PHASE I INSPECTION REPORT
NATIONAL DAM SAFETY PROGRAM
PATTERSON, BRIXIUS, GREY CREEK
WATERSHED PROJECT - SITE 1
I.D. No. NY 698
DEC #86B-3457
SUSQUEHANNA RIVER BASIN
BROOME COUNTY, NEW YORK

PHASE I INSPECTION REPORT
NATIONAL DAM SAFETY PROGRAM

Name of Dam: Patterson Brixius Grey Creek Watershed Project,
Site 1 I.D. No. NY 698

Date of Inspection: July 23, 1980

Photo #2
Upstream Slope & Riser

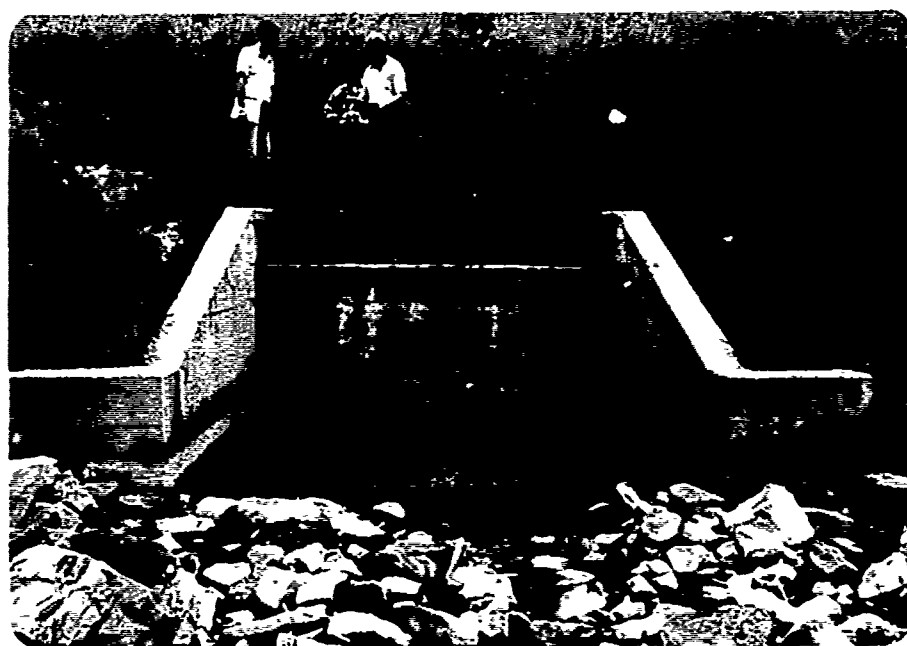
No signs of distress were observed in connection with the earth embankment and no signs of misalignment, sloughing, seepage, subsidence, surface cracking or undesirable growth were noted. While no riprap was in use on the upstream slope for wave protection, no erosion was apparent. (See Photos #1 & 2)
